**Author:** Marcelo Allende/ Ana Keeley  
**From:** AWN Consulting Ltd.  
**Date:** 4 February 2026  
**Reference:** LRD Barrysparks and Crowscastle, Swords, Co. Dublin

## RFI ITEM 5: LAND & SOILS AND WATER & HYDROLOGY

Fingal County Council (FCC) issued a Request for Further Information (FI) seeking clarification on various items, including those associated with item (5) and more specific, with Land & Soils and Hydrology & Hydrogeology aspects. The following sections include the responses prepared by AWN.

**Figure 1 – Site Investigation Points (Source: IGSL, 2024)**

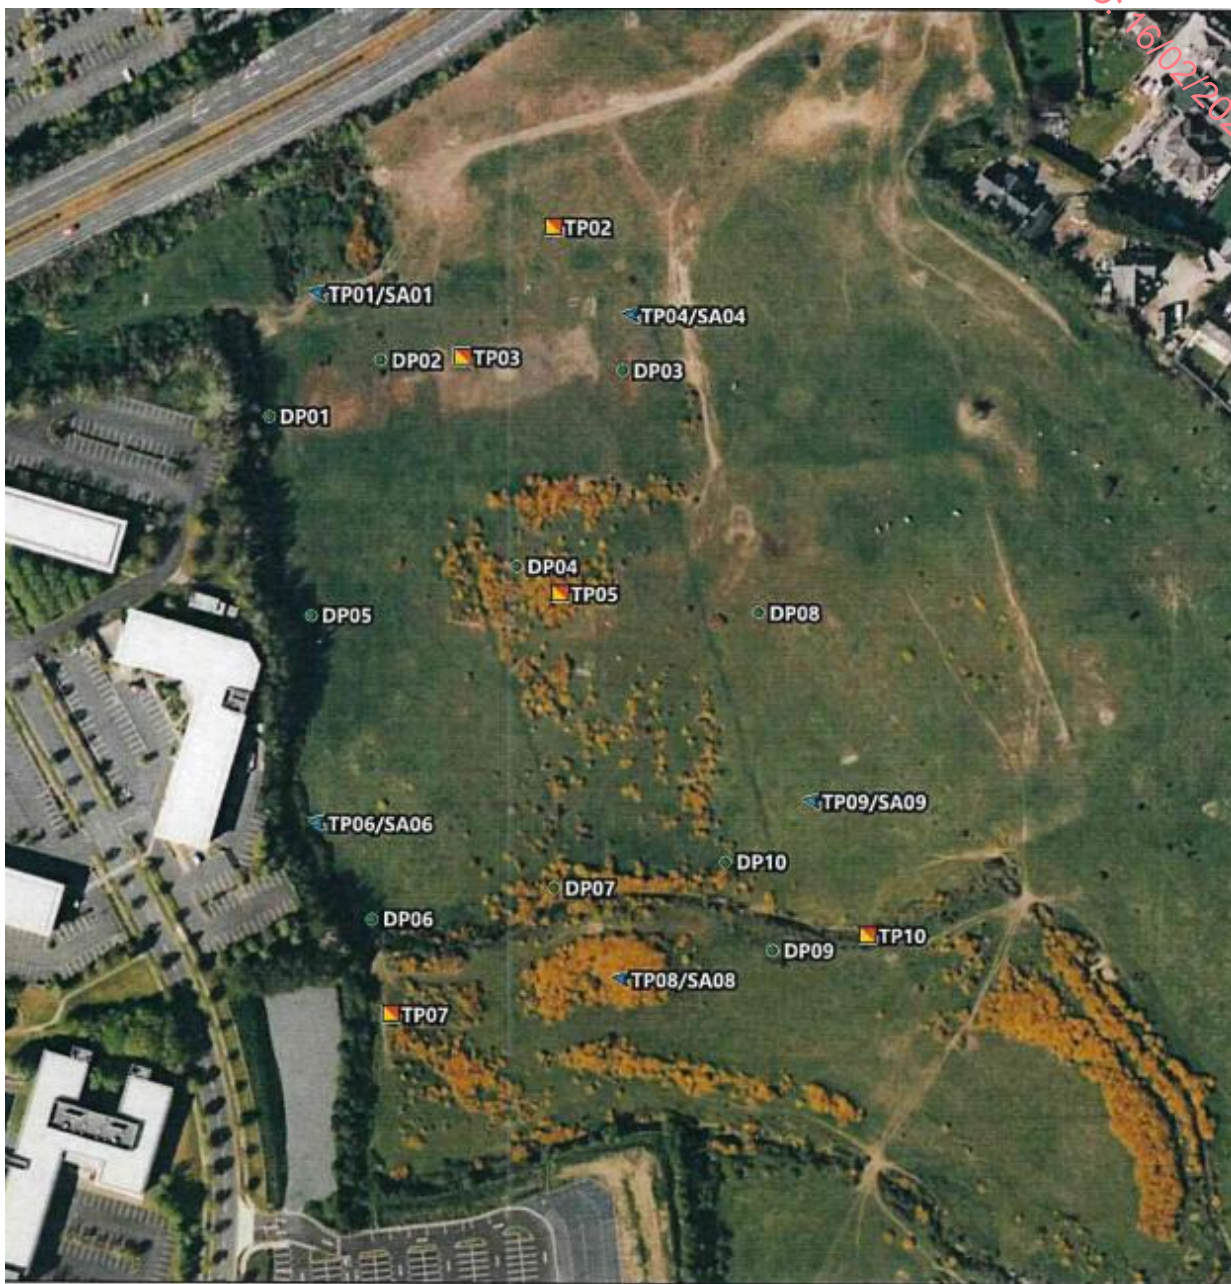
- (i) **The site investigation described in the chapter was undertaken in 2020 and is stated to be included as Appendix 5.2. Only Appendix 5a has been provided which contains reports from two other site investigations completed in August 2024 (Barrysparks Site 1) and August 2024 and January 2025 (Barrysparks Site 2). Figure 5.6 shows an incorrect site boundary. The applicant is requested to update the chapter to reflect the results of the latest site investigations undertaken at the proposed development site, as appropriate.**

Reference to Appendix 5.2 at Section 5.3.4 is an error and should state Appendix 5A. As mentioned in the request, the original Appendix 5A contains site investigation reports completed in August 2024 (Barrysparks Site 1) and August 2024 and January 2025 (Barrysparks Site 2).

Ground investigation and subsoil assessment of the proposed development site and surrounding lands were undertaken by IGSL in June 2024, with revised works completed in January 2025. The investigation carried out in June 2024 comprised the excavation of ten trial pits (Refer to Figure 1 below), together with geotechnical laboratory testing and a Waste Characterisation Assessment (WCA). The ground conditions encountered generally comprise the following sequence of strata:

- ▶ **Topsoil:** Encountered in trial pits located in the centre of the site (TP04, TP05, TP08, TP09, and TP10) from ground level to a maximum depth of 0.40 m below ground level (BGL).
- ▶ **Made Ground / Fill:** Encountered in TP01, TP02, TP03, TP06, and TP07 from ground level to a maximum depth of 2.10 m BGL. These deposits generally contained fragments of concrete and red brick.
- ▶ **Cohesive Deposits (Gravelly Clay):** Encountered in all trial pits to a maximum depth of 3.60 m BGL.

Trial pits were excavated to depths ranging between 2.50 m and 3.60 m BGL, with termination generally due to obstructions. These obstructions are considered likely to comprise tightly compacted cohesive

deposits containing boulders, rather than underlying bedrock. No significant groundwater seepages were observed, with only minor ingress recorded in TP01, TP02, TP03, and TP09 below depths of 2.00 m BGL. Soil samples were collected from each trial pit location and classified as non-hazardous. The full Site Investigation Report is included in Appendix 5.B.

**Figure 4 – Surface Water Sampling Locations**

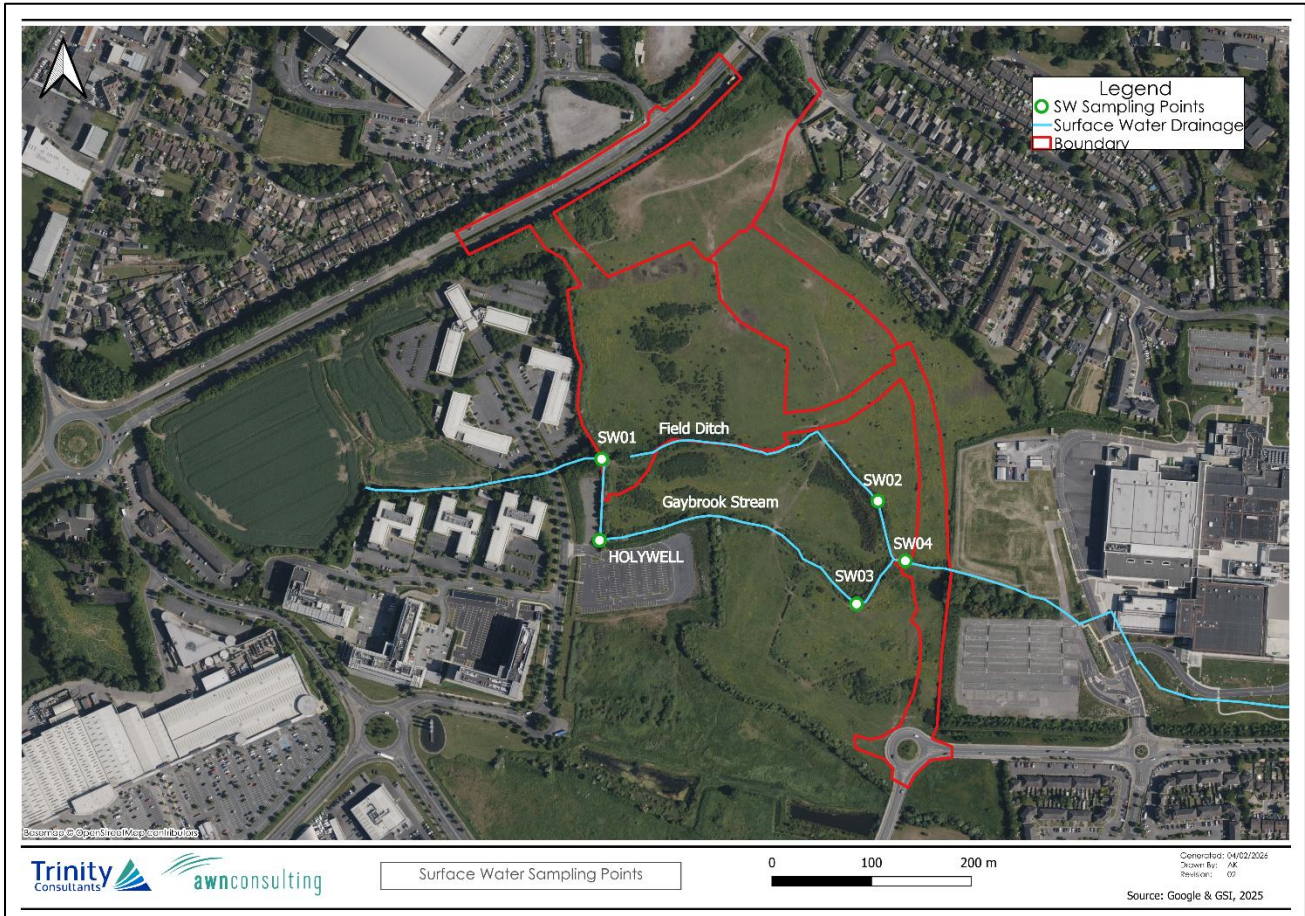
- (i) **The applicant is requested to provide baseline water sampling results, compared against appropriate standards, and update the assessment as required.**

AWN carried out a surface water quality assessment on the 10th of December 2025 in order to compare the existing baseline water quality conditions against Surface Water EU Environmental Objectives (SI 272/2009 and 77/2019 amendments). Figure 4 below shows the proposed site location with the Local Ditch and Gaybrook Stream running south of the proposed site, as well as the surface water sampling locations.

- ▶ SW01: Gaybrook Stream upstream the Proposed Development.
- ▶ SW02: Field Ditch upstream Gaybrook Stream.
- ▶ SW03: Gaybrook Stream upstream Field Ditch.
- ▶ SW04: Gaybrook Stream downstream Field Ditch and Proposed Development.
- ▶ Holywell (upwelling well; groundwater).

It should be noted that the Local Ditch is not connected to the Gaybrook Stream upstream at the western boundary of site. The Gaybrook Stream enters the Barrysparks lands at the western boundary from Airside Business Park. The stream turns south along the western boundary and then turns east across the site to divide the site into north and south
